McCULLOCH SERVICE BULLETIN

NO. 1609

MODEL All 10 Series Type Saws DATE July 1, 1976

SUBJECT 1. Service Replacement Connecting Rod Assemblies
2. Automatic Oiler Pad

303-1 **Figure 1**
P/N 65401

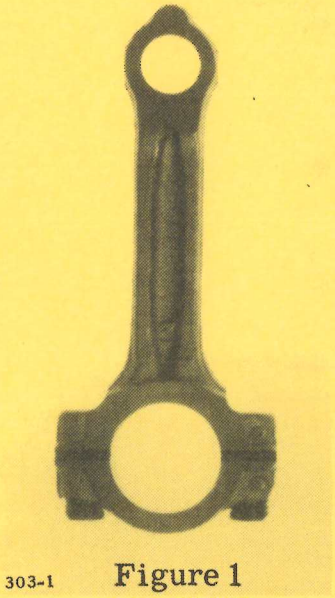
Connecting Rod Assembly, P/N 65401, now has cap screws installed from the bottom (Fig. 1). This change has been incorporated to improve the locking characteristics of the screws.

Connecting Rod, P/N 65401, with screws installed from the bottom, will fit all 10-10 models, Prefix 12 and above.

DO NOT install Connecting Rod, P/N 65401, in the following models as there may be possible interference between cap screw head and crankcase bottom:

Models 1-10, 2-10, 3-10, 4-10, 5-10 and early production 6-10 series engines.

Figure 2
P/N 92802

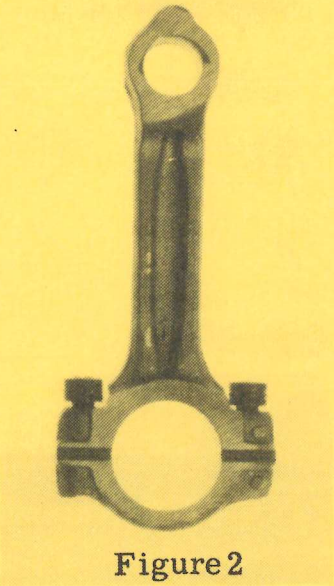
Connecting Rod Assembly, P/N 92802 (with cap screws installed from the top), must be used in above listed models (Fig. 2).
